**ADDENDUM
(AD)**

PROJECT: Nebraska Department of Transportation
District 1 Maintenance Facility
Seward, Nebraska

AD NO.: AD-2

DATE: December 10, 2024

1 Roof Framing Plan
1/8" = 1'-0"

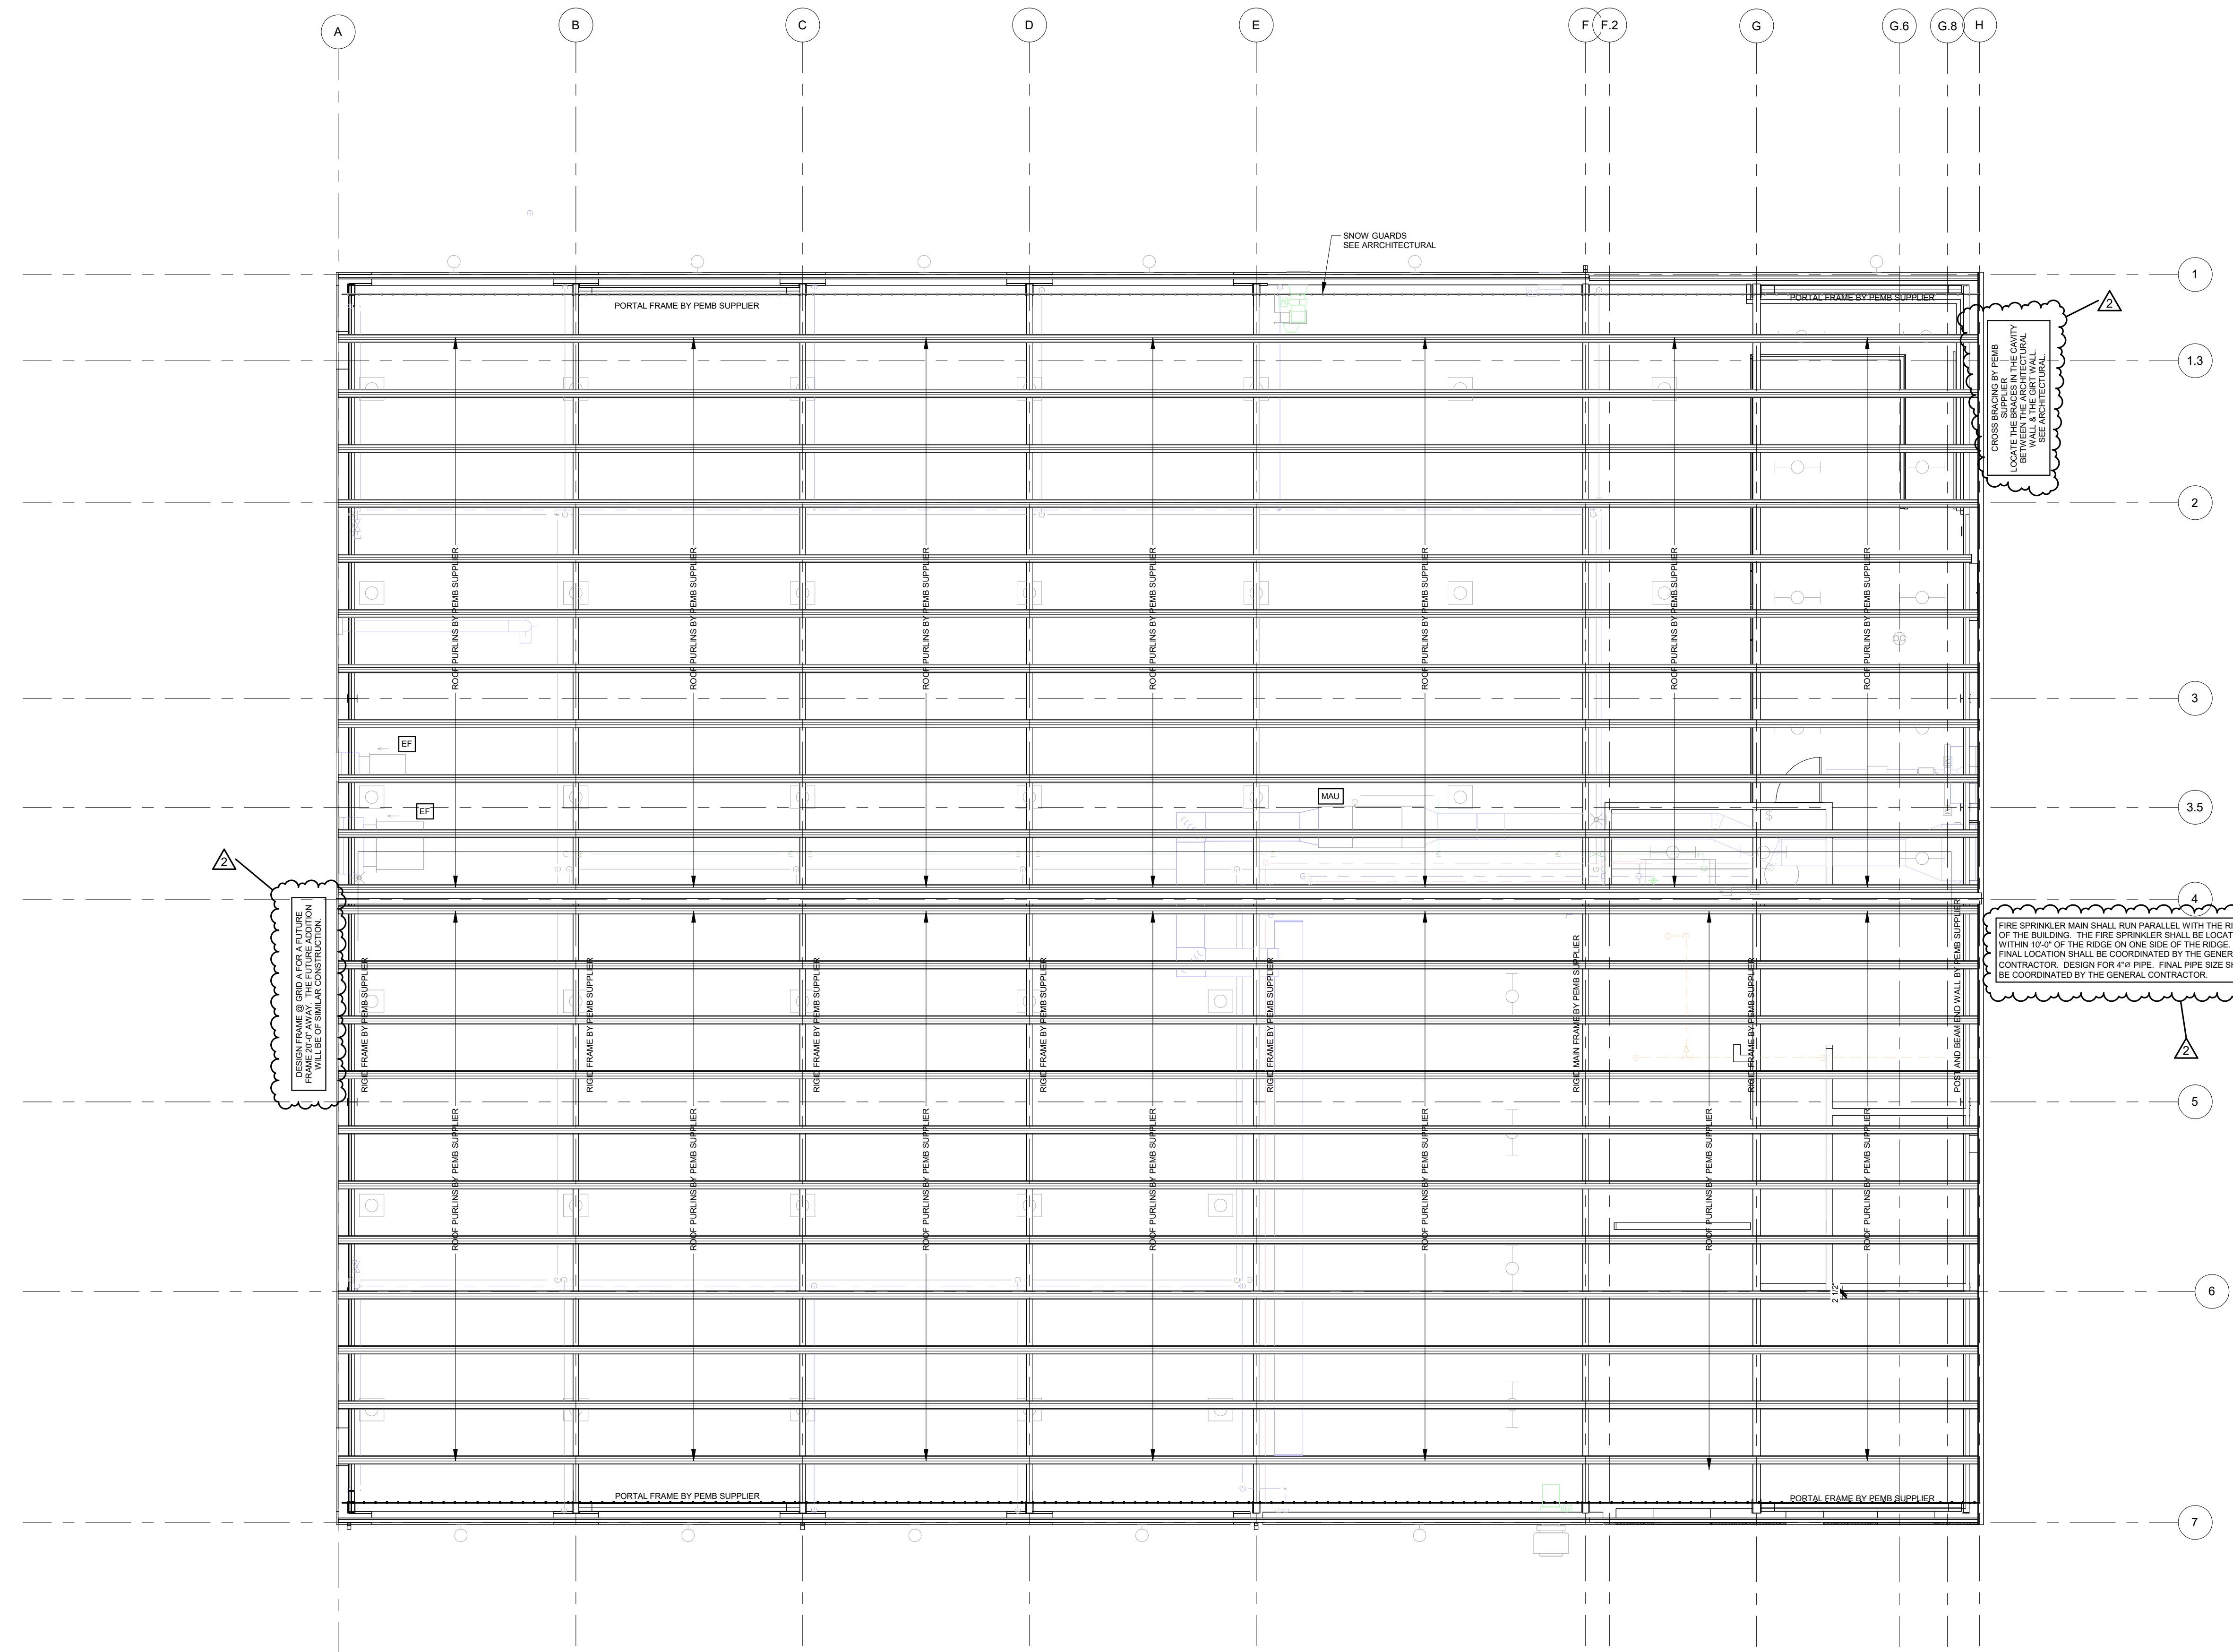
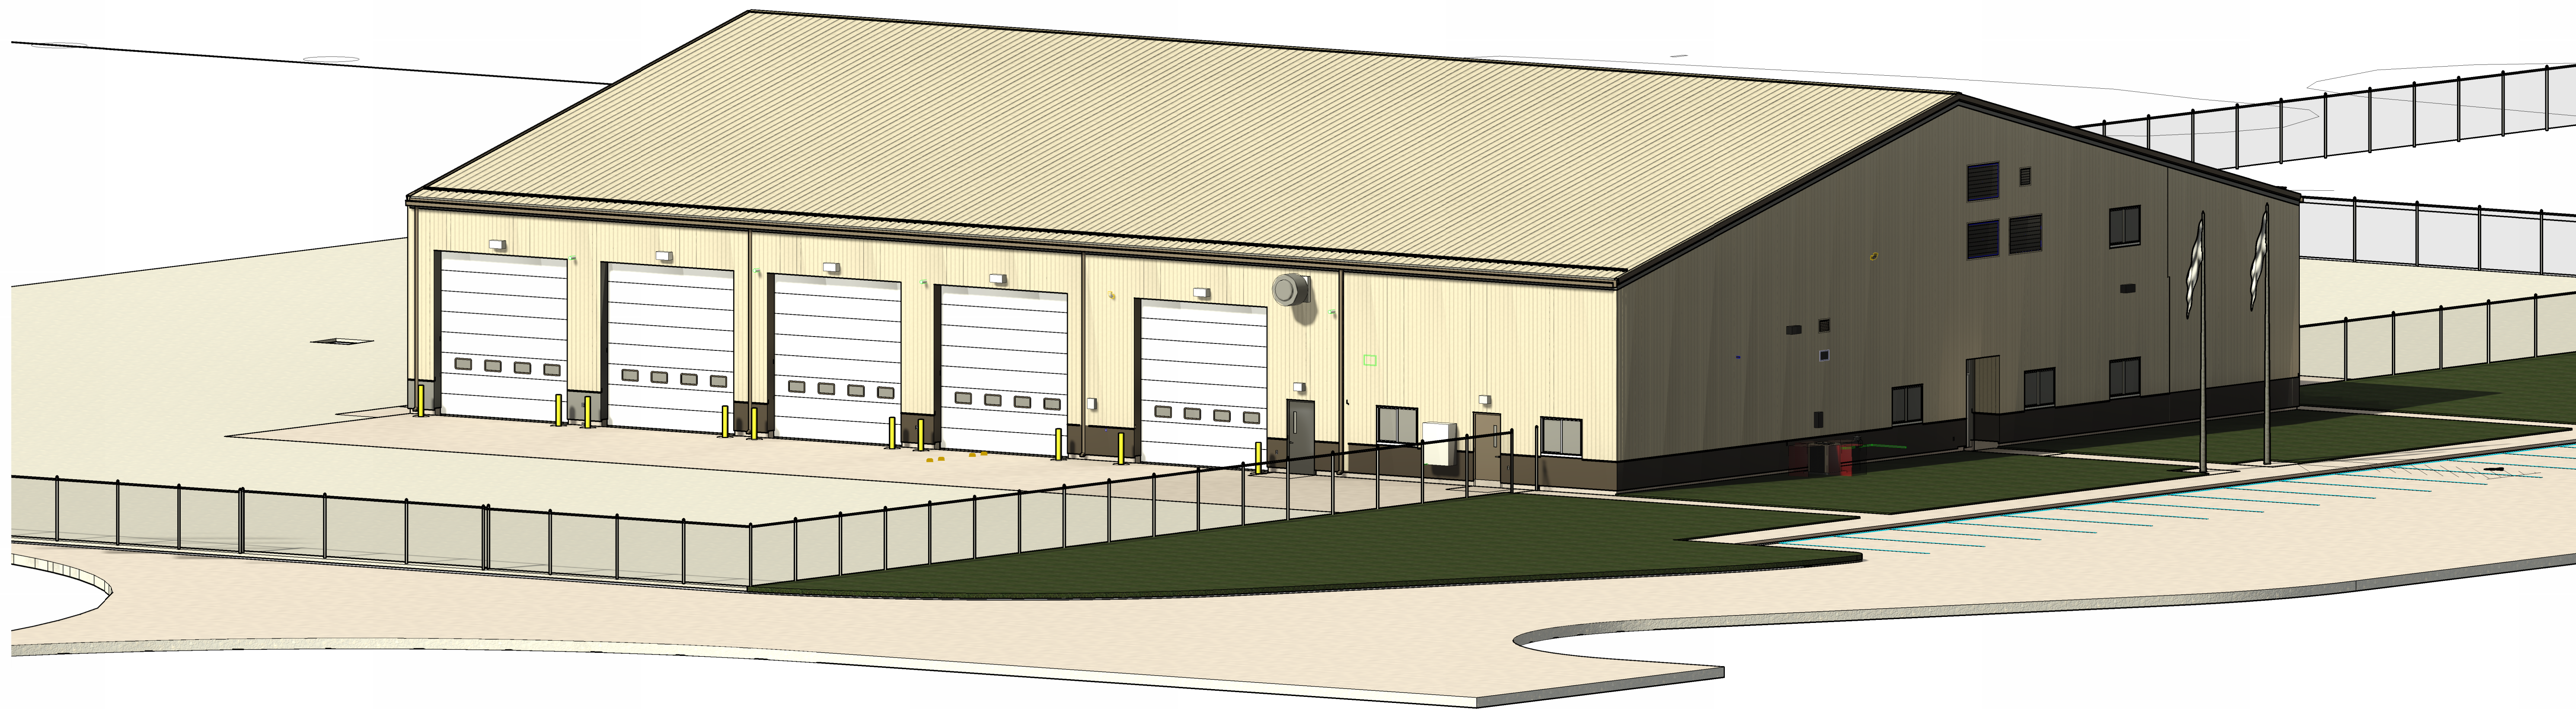
In reference to Sheet S-104 – ROOF FRAMING PLAN, see attached revised Sheet S-104. Design the frame at Grid A for a future frame 20'-0" away. The future addition shall be of similar construction and be a one bay addition.

In reference to Sheet S-104 – ROOF FRAMING PLAN, see attached revised Sheet S-104 adding cross bracing at Grid H between Grid 1 and Grid 2.

In reference to Sheet S-104 – ROOF FRAMING PLAN, see attached revised Sheet S-104 for added note for fire main pipe information.
